## Product / Process Change Notification (PCN)

<p><b>PCN #:</b> PCN_conDSUB_20230630</p> <p><b>Affected Series:</b> WR-DSUB ; 6180xx24823 ; 6180xx24923          6180xx221823 ; 6180xx221823 ; 6180xx25322</p> <p><b>PCN Date:</b> March 30, 2023</p> <p><b>Effective Date:</b> June 30, 2023</p>	<p><b>Change Category:</b></p> <p><input type="checkbox"/> Equipment / Location  <input checked="" type="checkbox"/> General Data  <input type="checkbox"/> Material  <input type="checkbox"/> Process  <input type="checkbox"/> Product Design  <input type="checkbox"/> Shipping / Packaging  <input type="checkbox"/> Supplier  <input type="checkbox"/> Software</p>
<p><b>Contact:</b> Product Management</p> <p><b>Phone:</b> +49 (0) 7942 - 945 5001</p> <p><b>Fax:</b> +49 (0) 7942 - 945 5179</p> <p><b>E-Mail:</b> pcn.eican@we-online.com</p>	<p><b>Data Sheet Change:</b></p> <p><input checked="" type="checkbox"/> Yes      <input type="checkbox"/> No</p> <p><b>Attachment:</b></p> <p><input type="checkbox"/> Yes      <input checked="" type="checkbox"/> No</p>

## 2. 6180xx24923

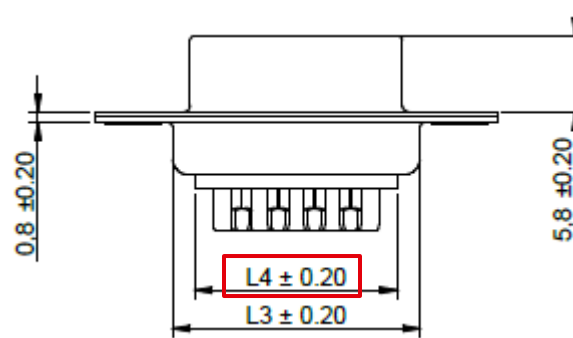
Part Number	ARTICLE PROPERTIES	MATERIAL PROPERTIES
		L4 (mm)	Shielding Plating
<b>BEFORE</b>	61800924923	15.6	Nickel (Ni)
	61801524923	24.6	Nickel (Ni)
	61802524923	38.1	Nickel (Ni)
	61803724923	54.45	Nickel (Ni)
<b>AFTER</b>	61800924923	15.6	Tin
	61801524923	24.6	Tin
	61802524923	38.1	Tin
	61803724923	54.30	Tin

### 3. 6180xx221823

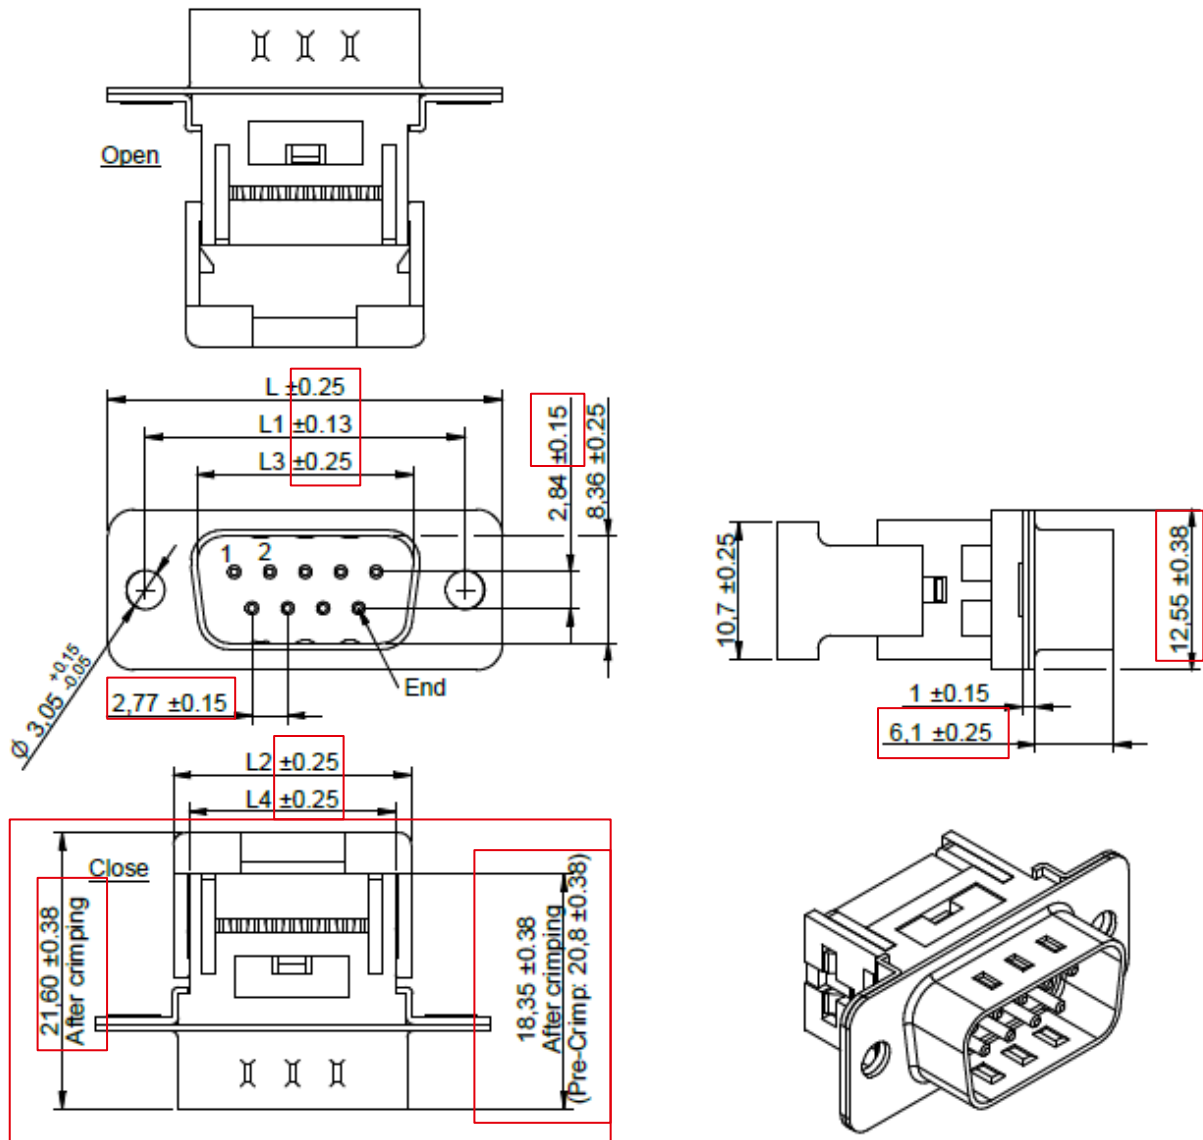
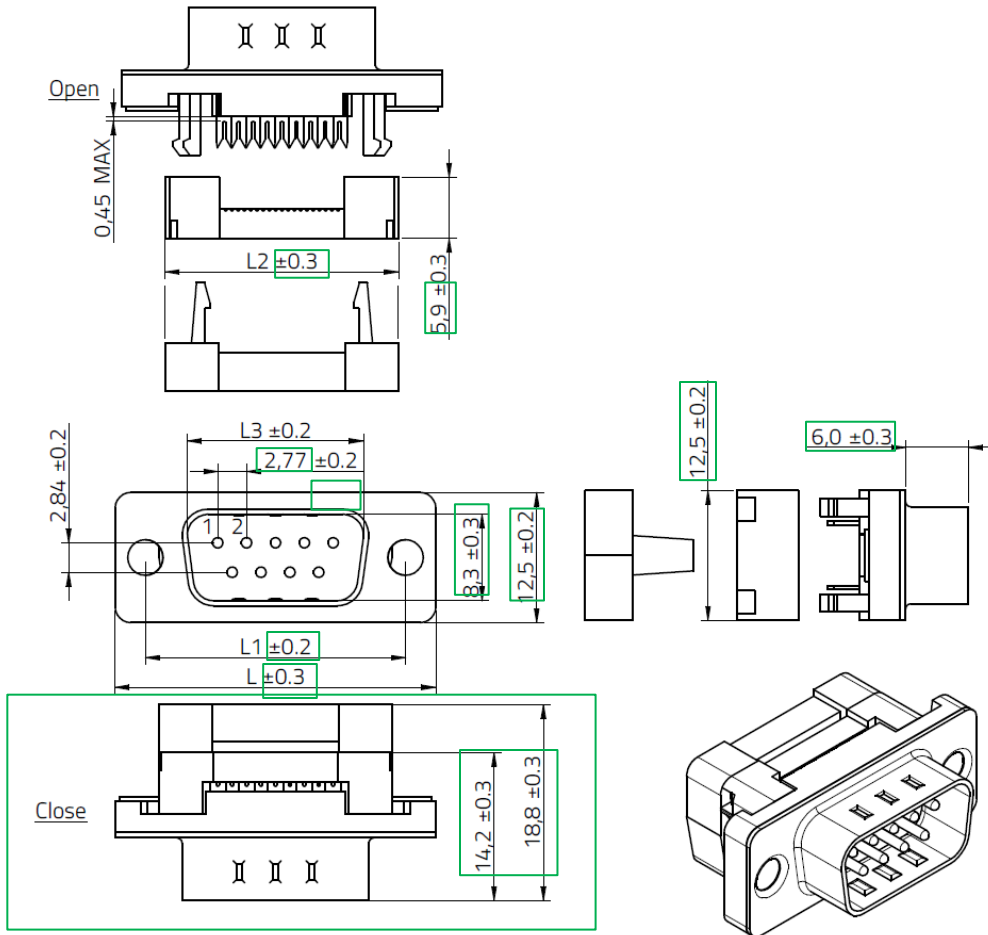
Part Number	MATERIAL PROPERTIES
		Insulator Color
<b>BEFORE</b>	618009221823	Not indicated
	618015221823	Not indicated
	618025221823	Not indicated
	618037221823	Not indicated
<b>AFTER</b>	618009221823	Blue
	618015221823	Blue
	618025221823	Blue
	618037221823	Blue

**4. 6180xx221923**

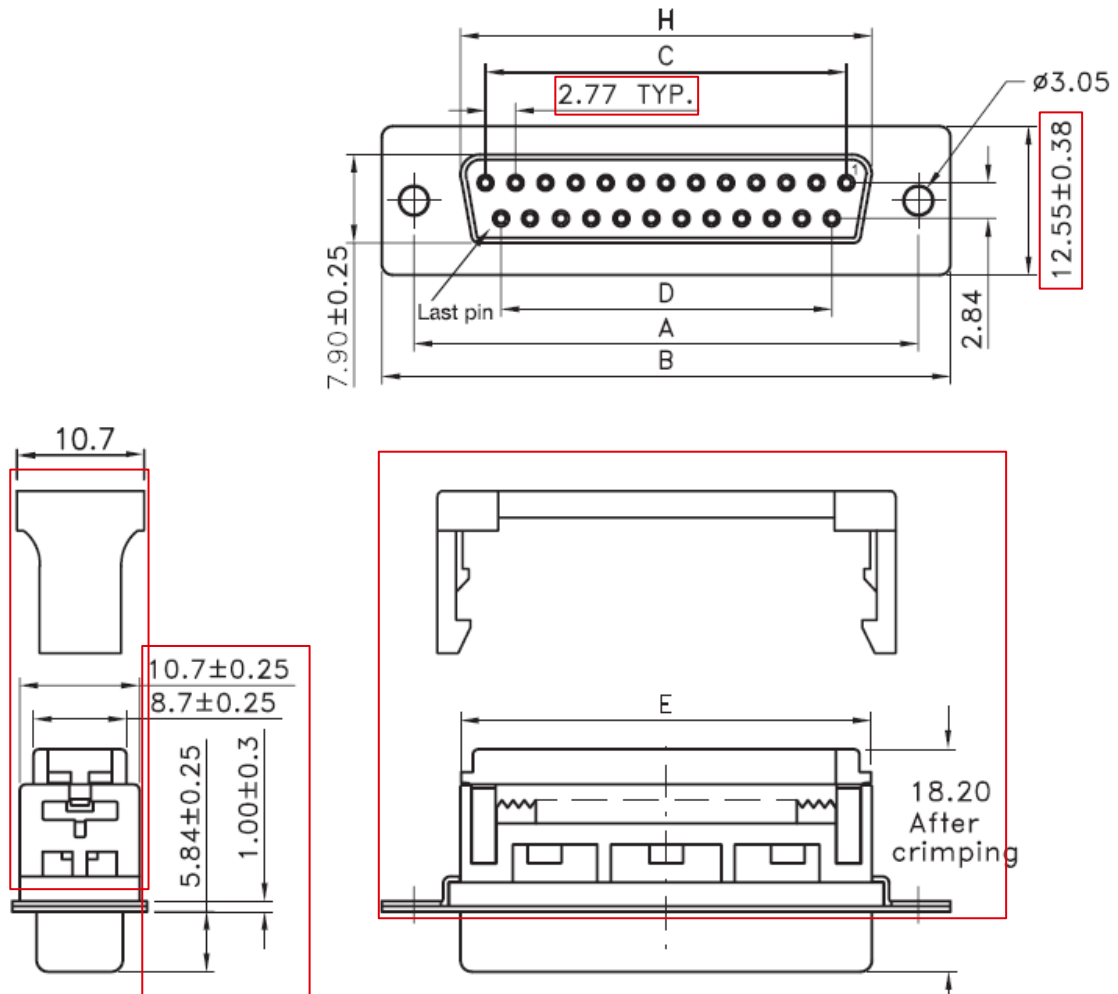
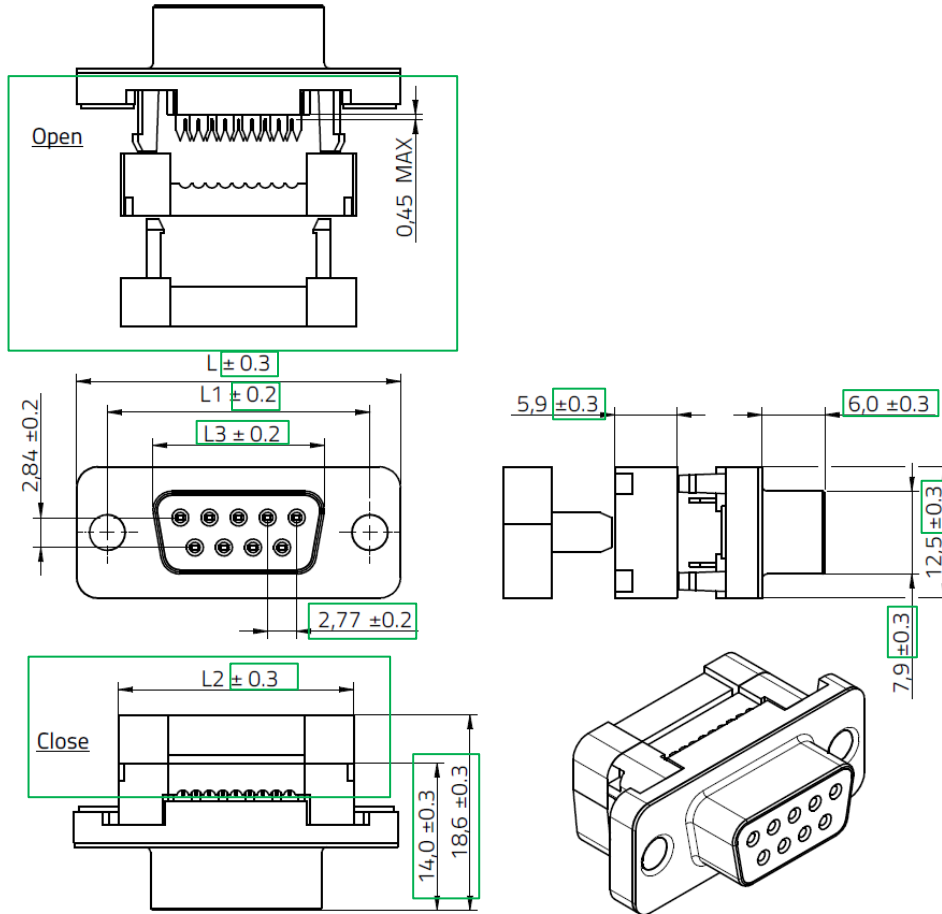
Part Number	ARTICLE PROPERTIES	MATERIAL PROPERTIES
		L3 (mm)	Insulator Color
<b>BEFORE</b>	618009221923	16.30	Not indicated
	618015221923	24.6	Not indicated
	618025221923	38.3	Not indicated
	618037221923	54.8	Not indicated
<b>AFTER</b>	618009221923	16.33	Blue
	618015221923	24.6	Blue
	618025221923	38.3	Blue
	618037221923	54.8	Blue
